AWC DATABASE CATALOG/ATLAS
CORRECTION FORM

Map: Icy Bay D-2 & D-3, D-2 & D-3 N, ~~Inset,~~ Icy Bay 1:250

Water Body Number: 191-20-13700

Nomination Number: 14-679

Figure 3.–Big River Braid addition map.

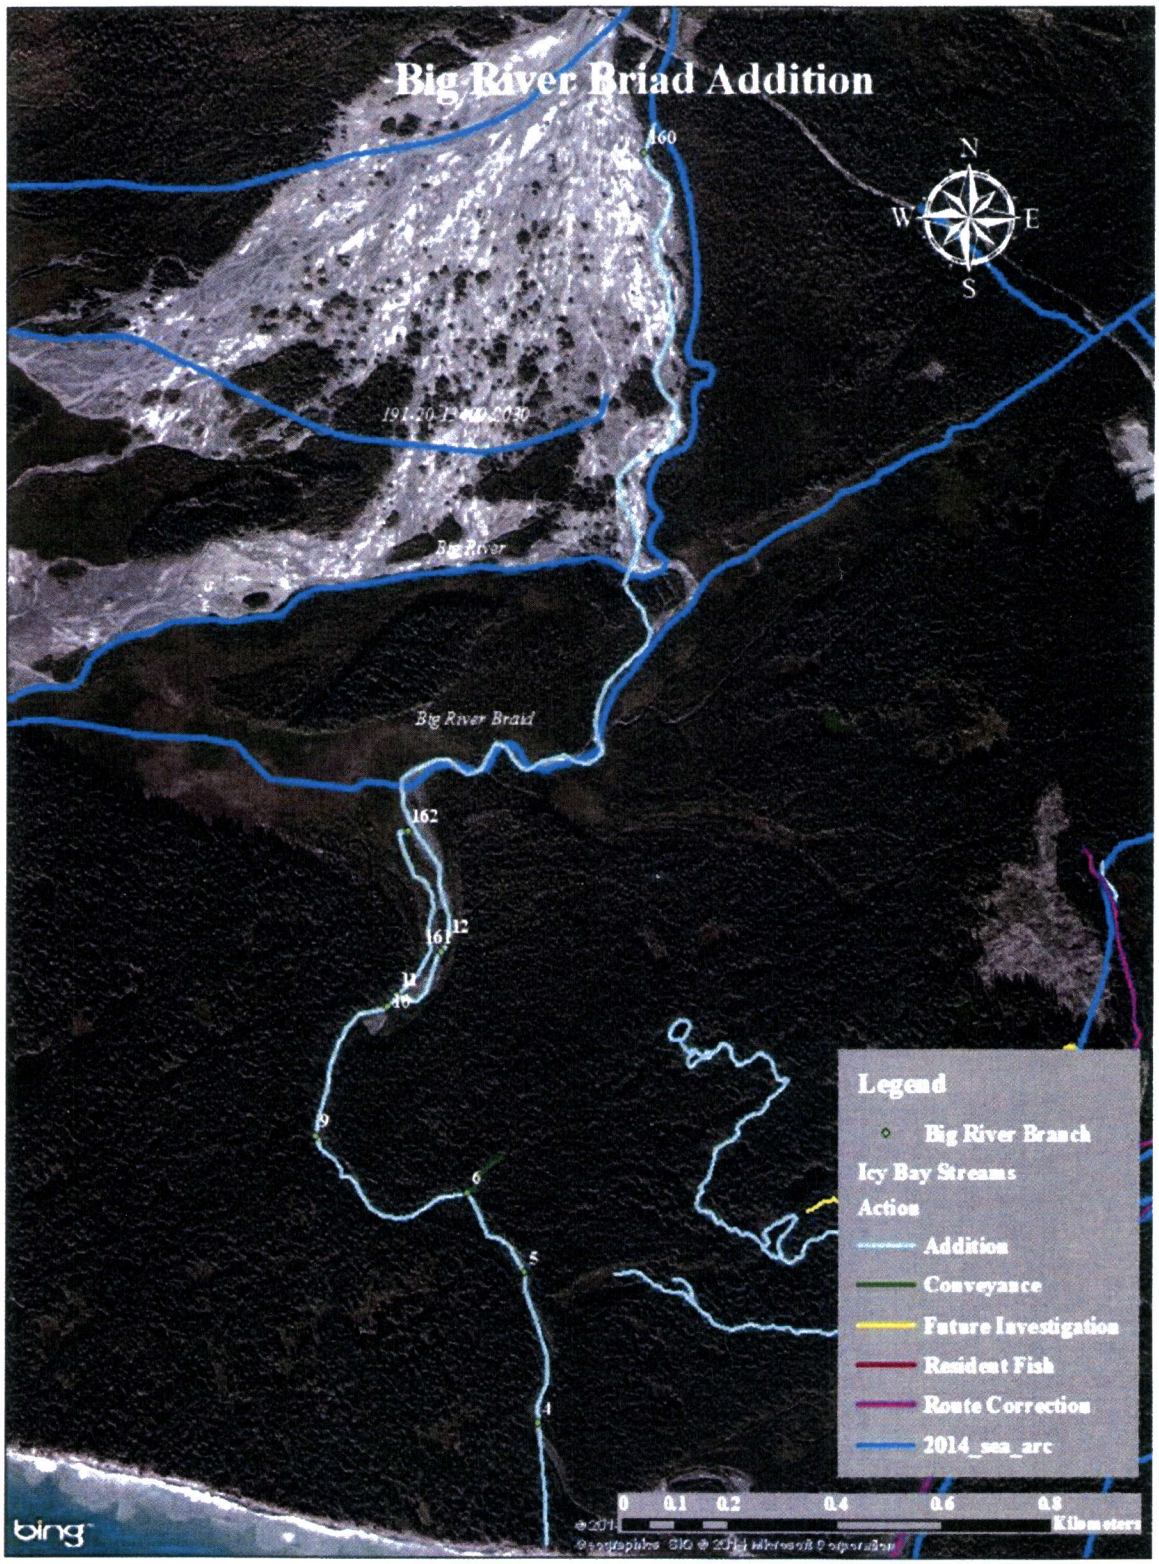
Recommendations: Add stream to AWC with the same stream number as Big River and its own arc line.
